Specification Mintech./CV2362 - CV2368
 Issue 2A, Dated September 1967
 To be read in conjunction with K1001
 ignoring clauses:- 5.2, 5.3, 5.8.

Type of Valve:- Magnetron
 Cathode:- Indirectly heated
 Envelope:- Metal glass
 Prototype:- M525

AMENDMENT No.1

ELECTRONIC VALVE SPECIFICATIONS
SPECIFICATION MINTECH/CV2362 - CV2368,
ISSUE 2A, DATED SEPTEMBER 1969
AMENDMENT NO 2

Page 5. Outline Drawing.

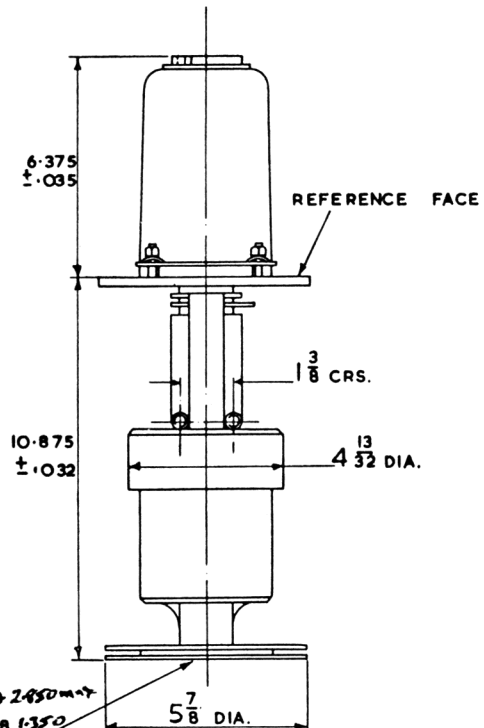
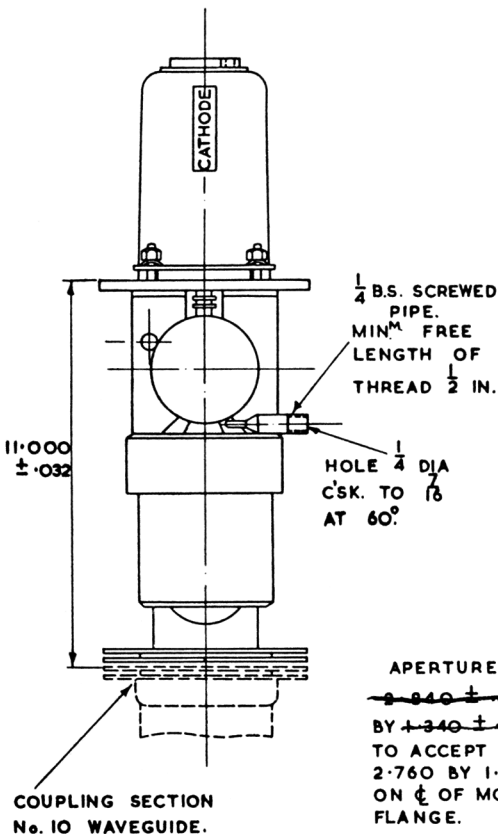
View in top right hand corner.

The flange diameter is shown as "6.000 Dia + .000"
- .000
which should be amended to read "6.000 Dia + .000"
- .010.

Delete the first two lines of the text " $2.840 \pm .008$ by $1.340 \pm .008$ " and insert " 2.850 max by 1.350 max"

APERTURE :-
~~2.40 $\pm$.008 2.450 mm~~
BY ~~1.340 $\pm$.008 1.350 mm~~
TO ACCEPT PLUG
2.760 BY 1.260
ON ϕ OF MOUNTING
FLANGE.
